HyNet Hydrogen Production Plant 1 – Technical Note

EPR Response 14d - Specification of WWTP-Wastewater Buffer Storage

Figure 2-1: Wastewater path to MBR

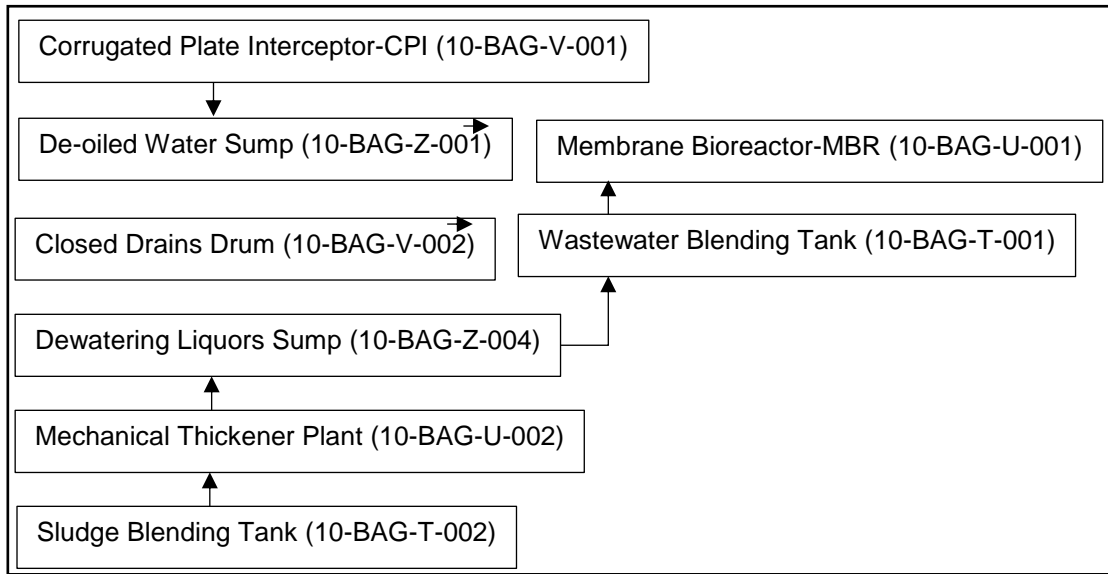
CWW BAT Conclusion 9: Provide a detailed description of the flexibility features and infrastructure serving the water treatment facilities, to ensure, in the case of off-spec effluent from the MBR, the stable operation of the hydrogen production plant (i.e. preventing the need for shut-downs and start-ups with the associated potential environmental impacts) and prevent uncontrolled emissions to water. Where appropriate, amend the design to include sufficient buffer storage capacity for off-spec waste water.

As required by CWW BAT conclusion 9, we would expect the proposal to include appropriate buffer storage capacity for wastewater incurred during other than normal operating conditions along with ancillary equipment to enable recycling and reprocessing of any off-spec effluent, whilst operational continuity of the HPP can be sustained by the raw water supply.

Refer simplified representative sketch shown below of wastewater path to the Membrane Bioreactor-MBR:

There will be capacities available in following equipment that can be used as buffer storage for the wastewater:

1. Wastewater Blending Tank (10-BAG-T-001)
2. De-oiled Water Sump (10-BAG-Z-001)
3. Closed Drains Drum (10-BAG-V-002)
4. Dewatering Liquors Sump (10-BAG-Z-004)
5. Sludge Blending Tank (10-BAG-T-002)

Sections below identify storage capacities of each equipment. These storage capacities provide the buffer storage for wastewater when MBR is non-operational.

The two main sources of wastewater to the MBR are De-Oiled Water Sump and Wastewater Blending Tank. De-oiled water sump has an approximate buffer of 4.5 hrs. The approximate buffer is 9.6 hr for the Wastewater Blending Tank. Additionally, Sludge Blending Tank feeding Wastewater Blending Tank also has 3 hr approximate buffer.

Hence, in case of a temporary outage of MBR, the wastewater treatment plant system tanks and sumps have buffer storage to keep the process plant running.
